Product Advisory: A136

Part Number: CLH-2 and CLH-5

Description: Clip SGD

Issue: H2S SGD clips programmed with incorrect alarm levels

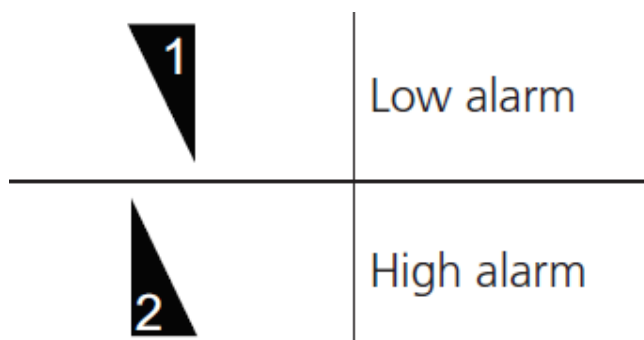
A batch issue has been identified whereby a small number of H2S SGD clips have been programmed with incorrect default alarm levels.

Part Number	Affected Serial Number Range	Specified Alarms Low / High ppm	Actual Alarms Programmed Low / High ppm
CLH-2	SI0310301-SI0310310	2 / 5	5 / 10
CLH-5	SI0324001-SI0324200	5 / 10	10 / 15

As the actual alarms are higher than the specified alarm levels, it is recommended that the alarm levels are restored to the specified levels. This can be achieved using the IR-LINK communications accessory and software, or using the Docking Station; please refer to the SGD user manual for instructions.

Alternatively, the SGD can be returned to your Crowcon Distributor for modification. *Distributors should refer to Technical Note CC0007 (Issue 2) SGD Firmware Upgrade instructions, for instructions on upgrading firmware and restoring factory default alarms.*
